FINAL DRAINAGE PLAN

THE RIDGE AT LORSON RANCH

JANUARY, 2022

Core Engineering Group, LLC
15004 1ST Avenue South
Burnsville, MN 55306
(719) 570-1100

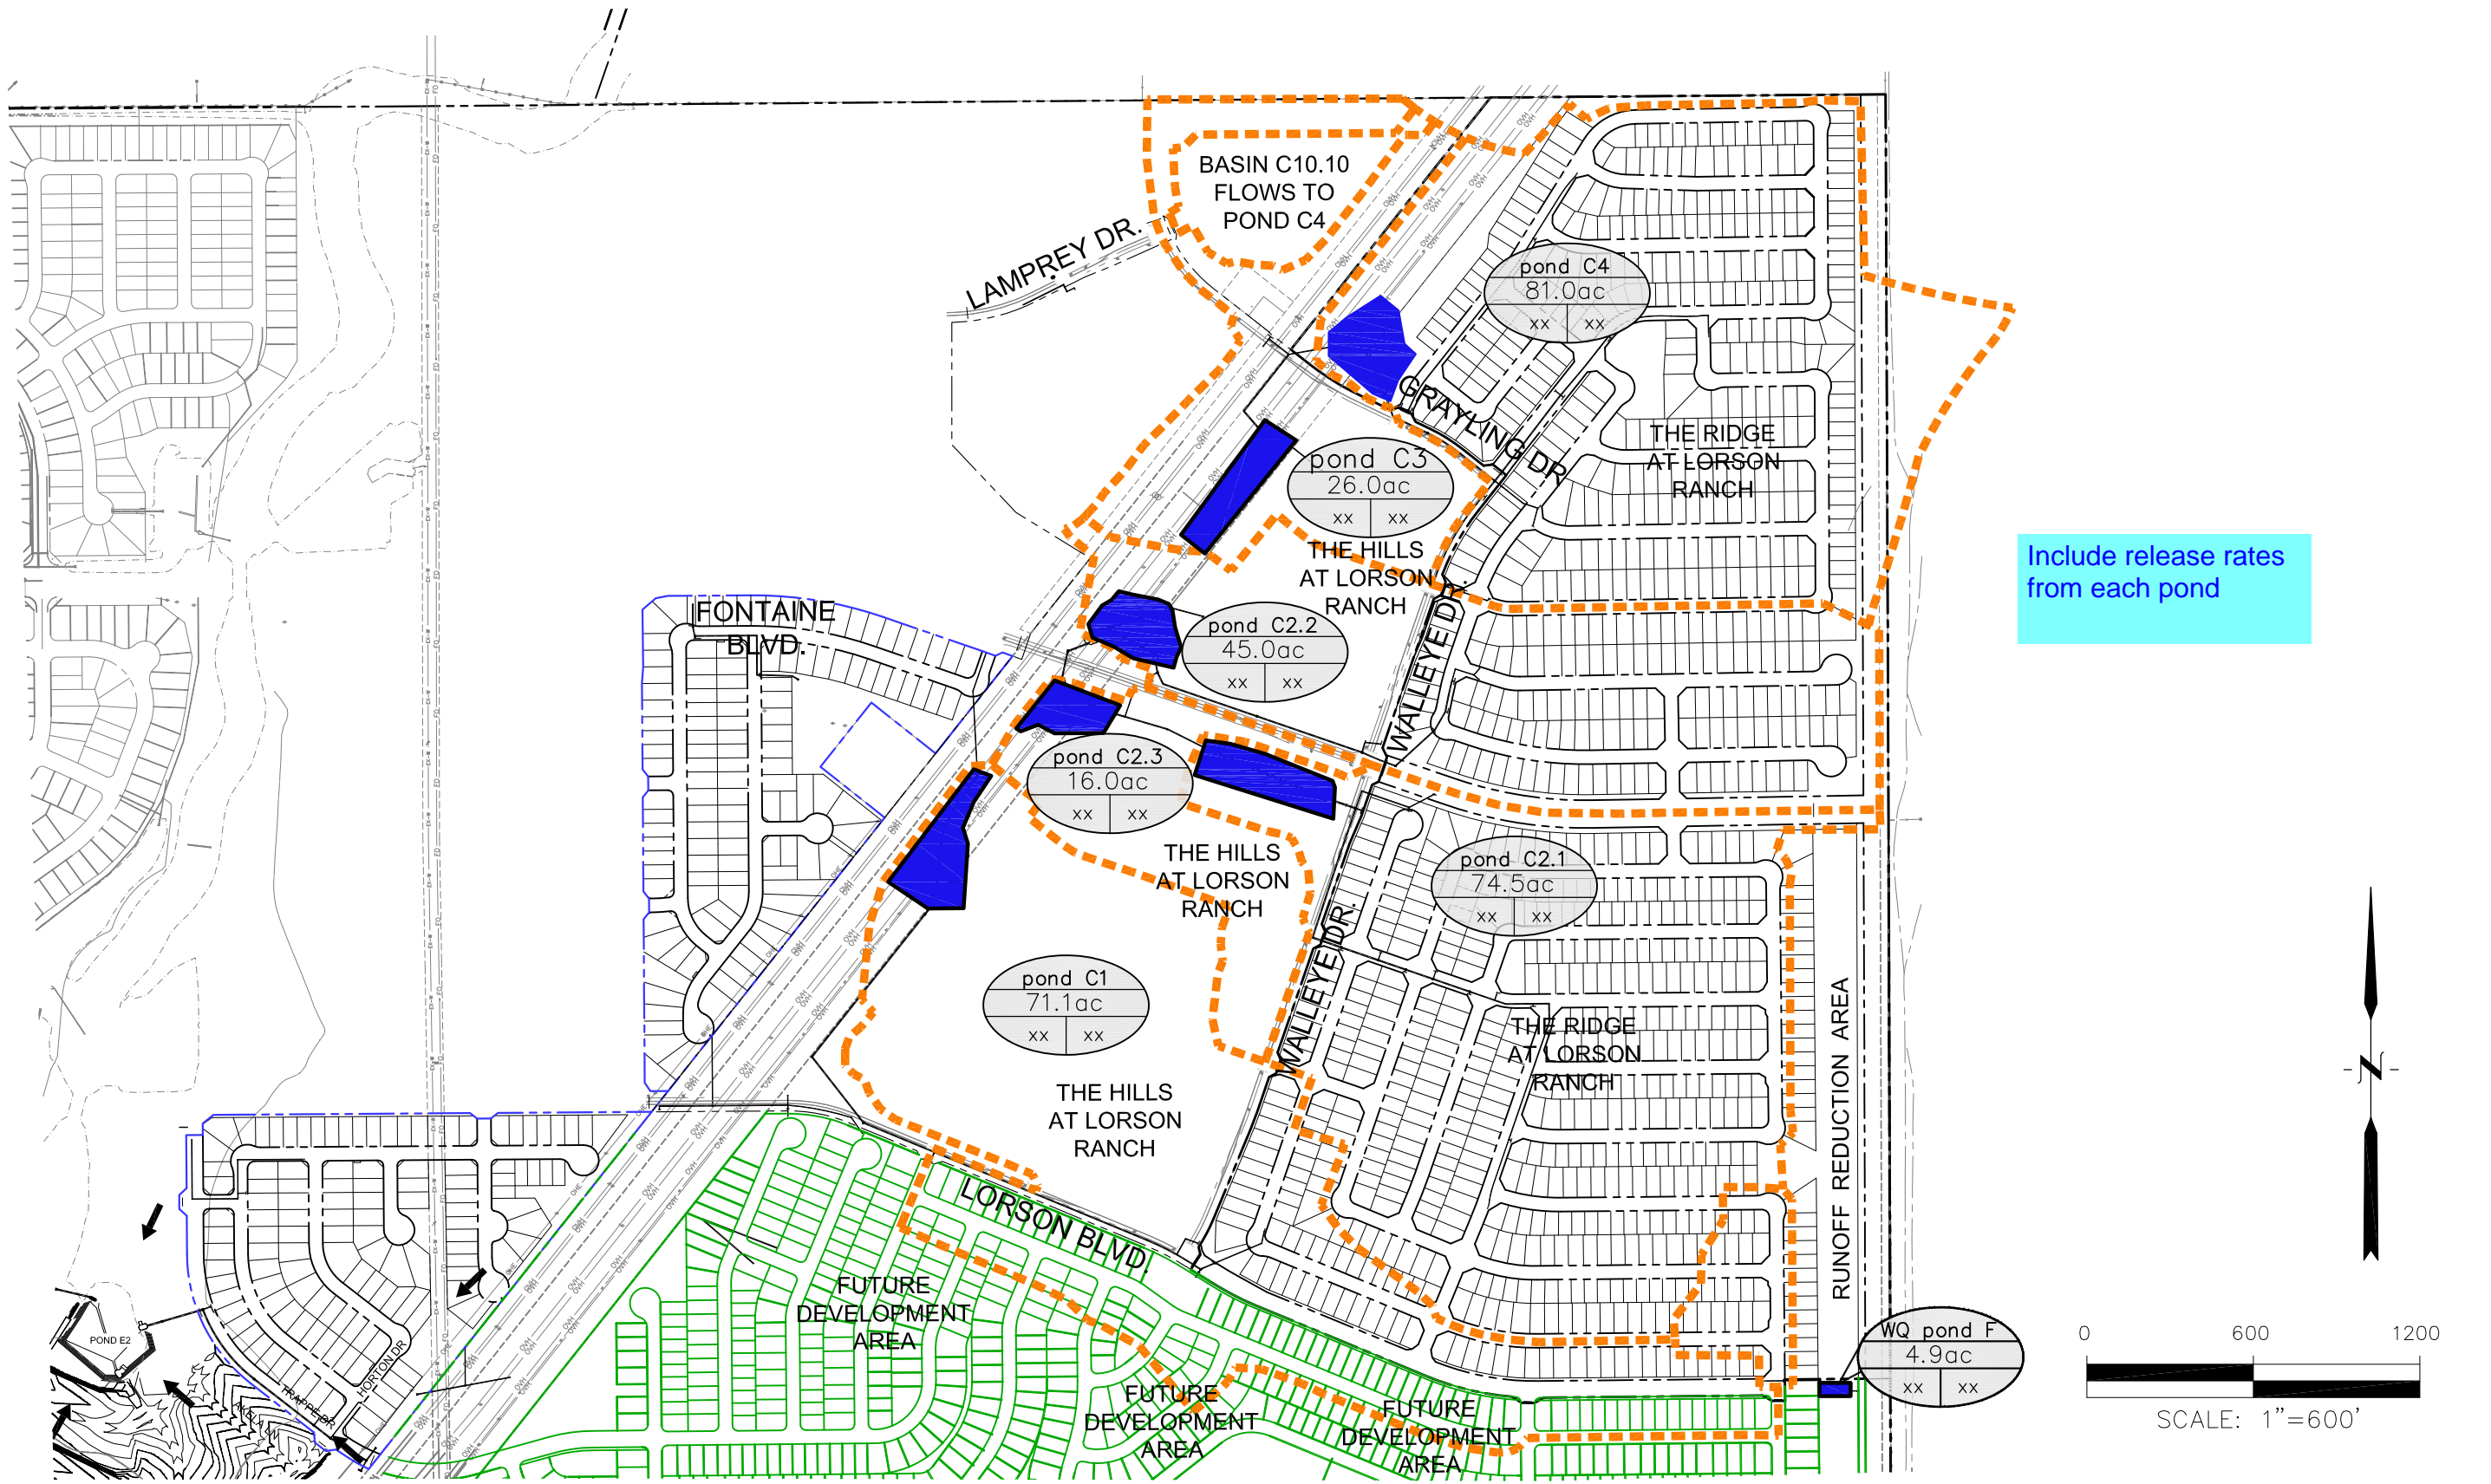
Please include spreadsheet/table listing contributing basins and % impervious to each pond.

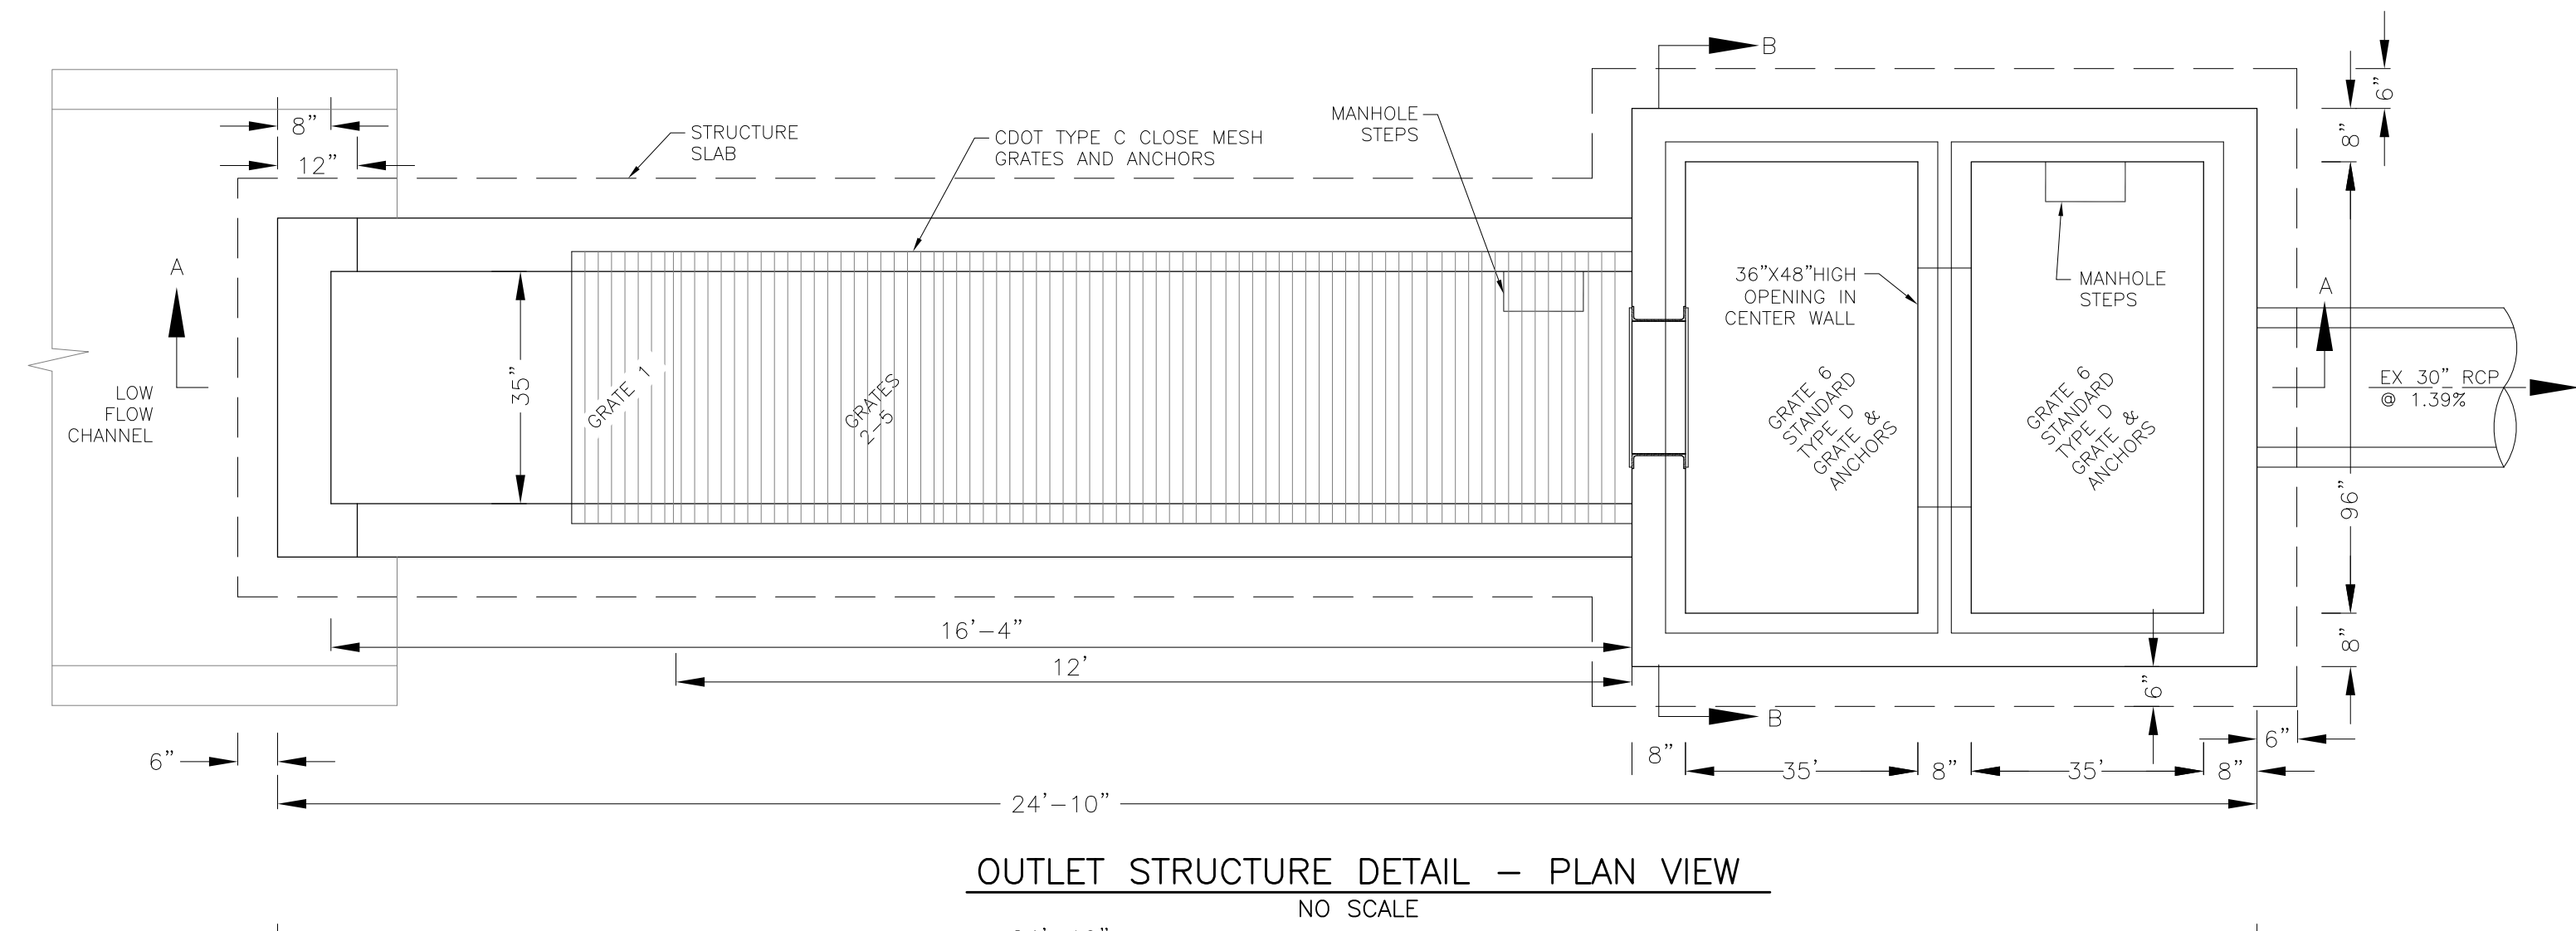
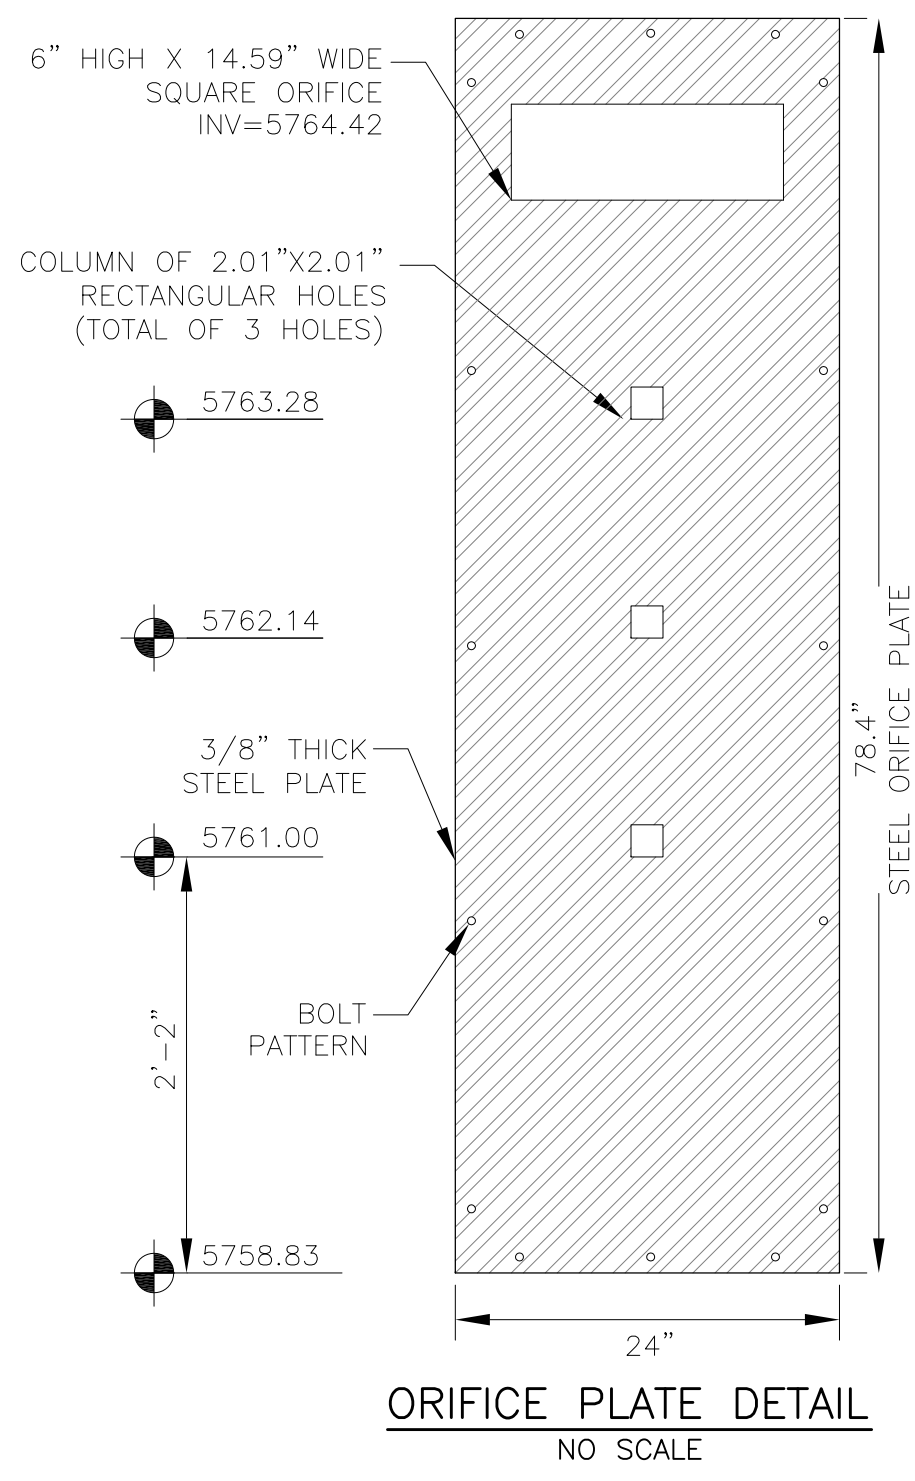
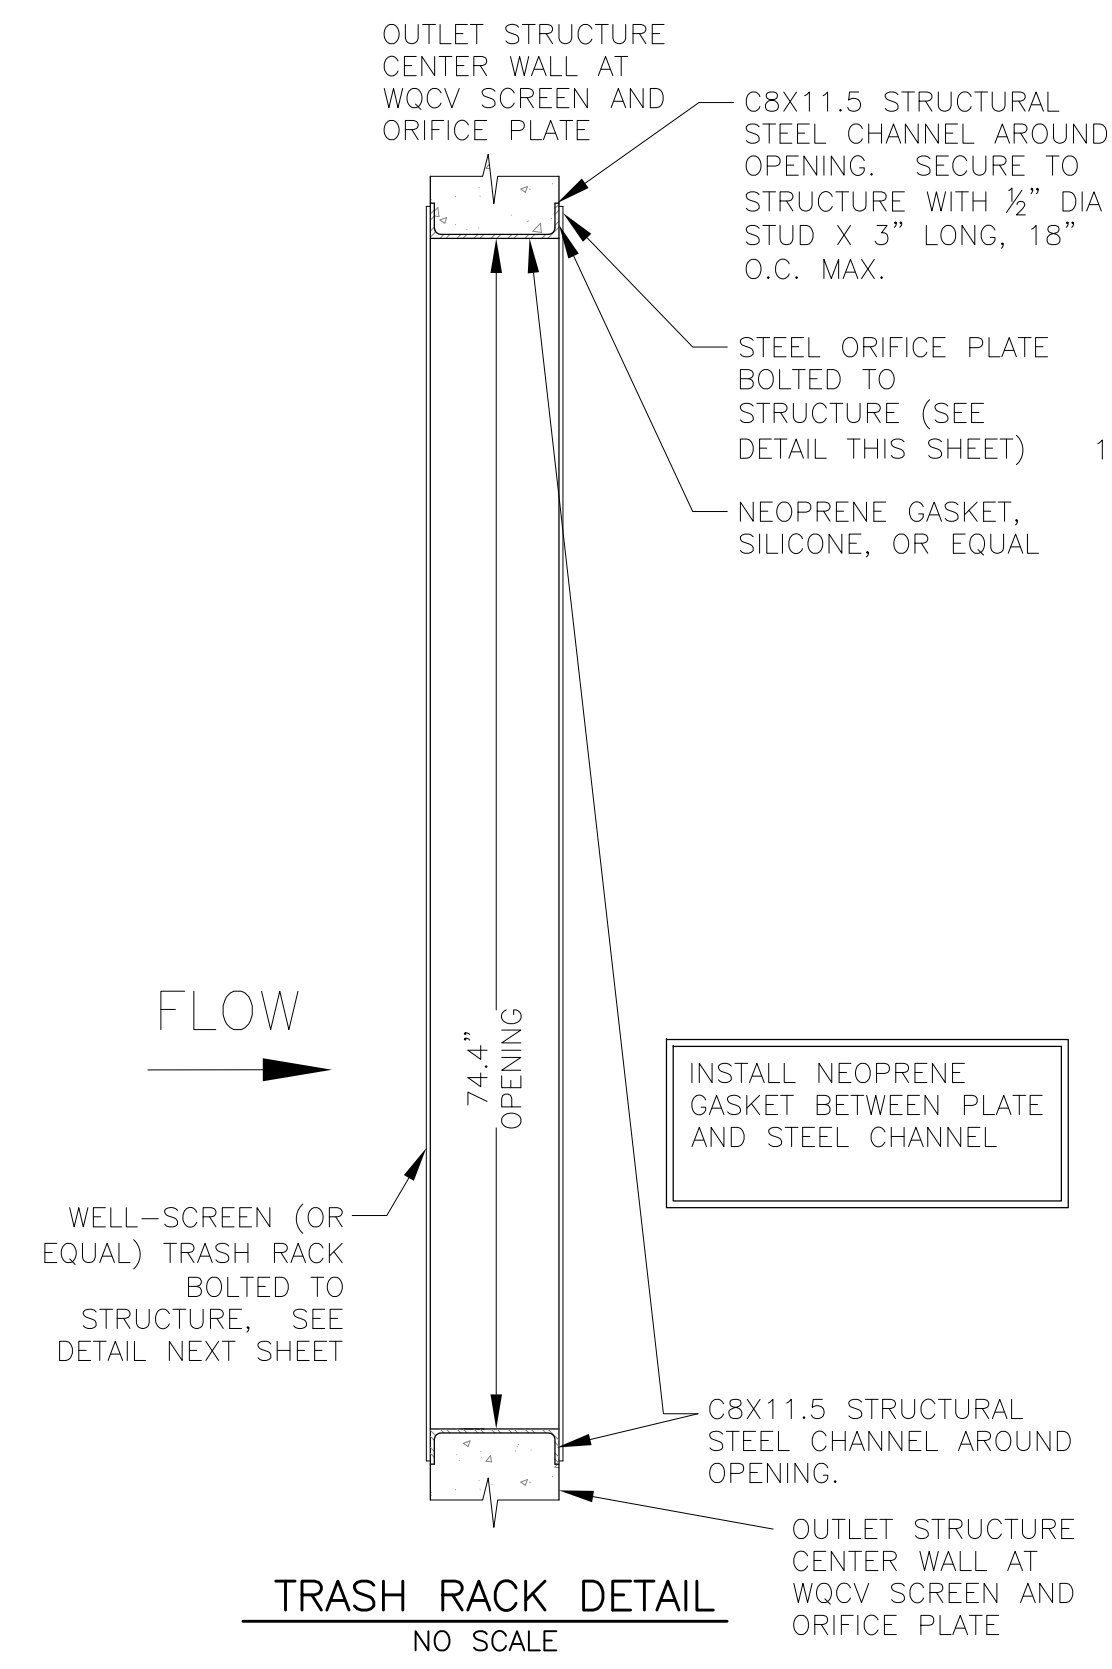
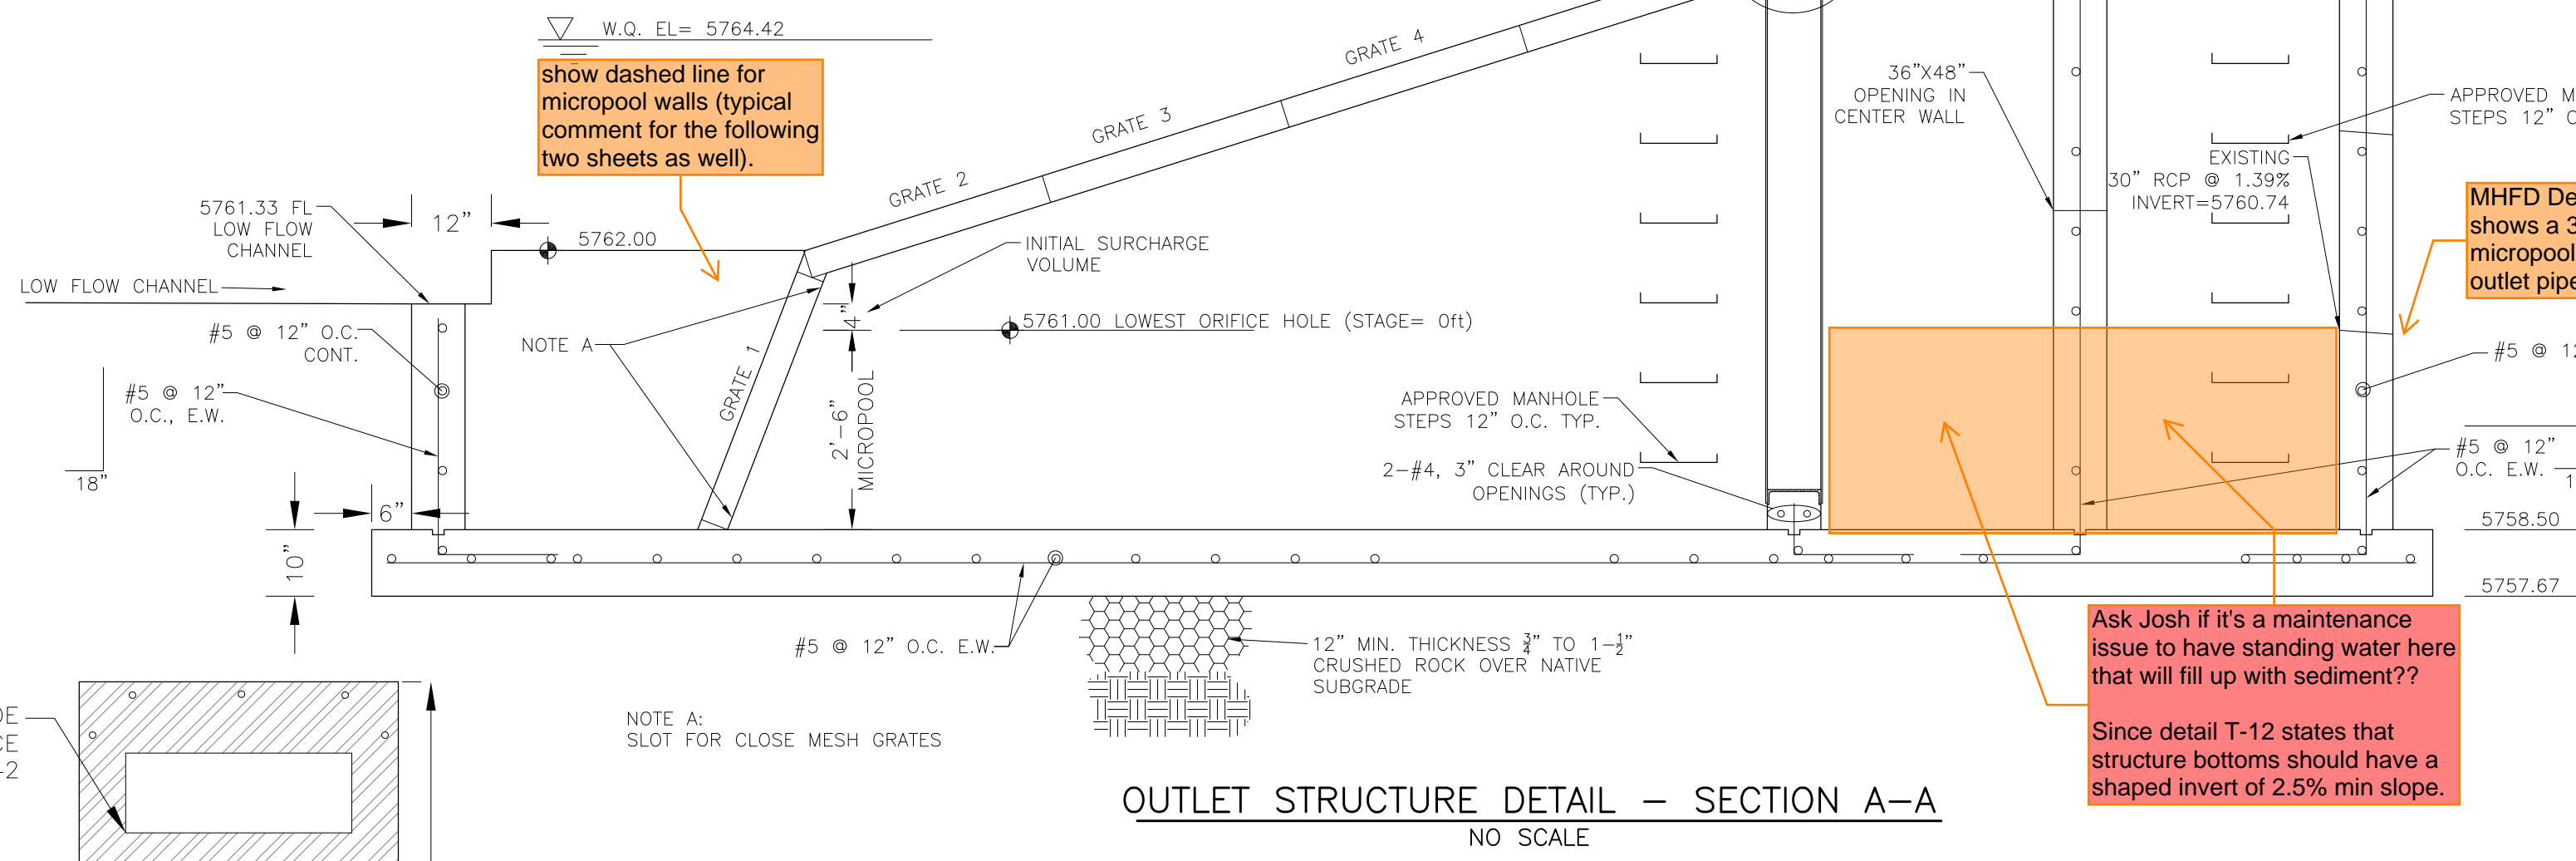
This sheet and the other two sheets below this one need to be included in the CD's.
